Access Compliance Report

Public Rights-of-Way

(Curb Ramps)

Intersection ID: N/A	Main Street: E_STONEWALL_ST	Cross Street: MCDOWELL_ST	Location: E
ADA ID: 559EDB50D7FB	Ramp Type: Perp	Initial Pass/Fail: Fail	Overall Compliance: No
Severity Score: 21.25			
Codes/Mitigation Info/Possible Solution		Field Measurements/Component Compliance

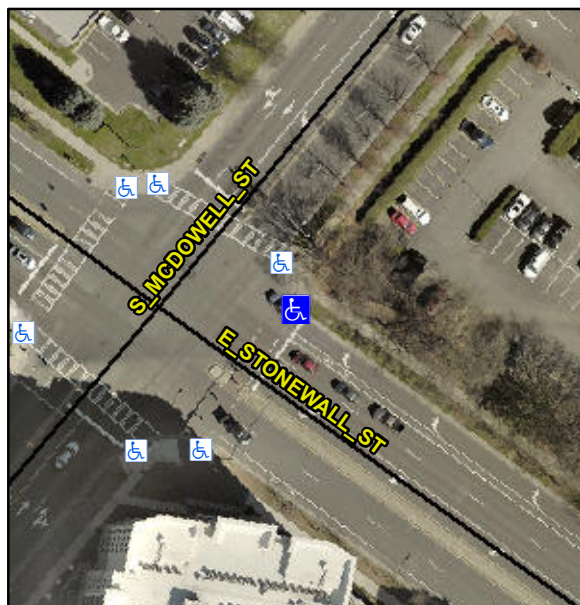
Not Found, R304.5.1, R304.2.2

Compliance	Description	Data	Compliance	Description	Data
N/A	Ramp Length (in)	94.0	No	Ramp Slope (%)	9.8
No	Ramp Width (in)	46.0	Yes	Ramp XSlope (%)	2.0
N/A	Flare Type LT	N/A	N/A	Flare Type RT	N/A
N/A	Flare Slope LT (%)	N/A	N/A	Flare Slope RT (%)	N/A
N/A	Flare Traversable LT?	N/A	N/A	Flare Traversable RT?	N/A
N/A	Landing Length (in)	N/A	N/A	DWS Provided?	N/A
N/A	Landing Width (in)	N/A	N/A	DWS Contrast?	N/A
N/A	Landing Slope (%)	N/A	N/A	DWS Length (in)	N/A
N/A	Landing X Slope (%)	N/A	N/A	DWS Full Width?	N/A
N/A	Landing Curb? (Y/N)	N/A	N/A	DWS Offset (in)	N/A
N/A	Shared Landing?	N/A			
N/A	Gutter Ponding?	N/A	N/A	Gutter Slope (%)	N/A
N/A	Gutter Lip Ht (in)	N/A	N/A	Gutter X Slope (%)	N/A
N/A	Painted X Walk1?	Yes	N/A	Painted X Walk2?	N/A
	X Walk 1 Direction	To SW		X Walk 2 Direction	N/A
N/A	X Walk 1 Width (in)	122.0	N/A	X Walk 2 Width (in)	N/A
	X Walk 1 Slope (%)	1.5		X Walk 2 Slope (%)	N/A
	X Walk 1 X Slope (%)	2.4		X Walk 2 X Slope (%)	N/A

Remove & Replace Entire Ramp.
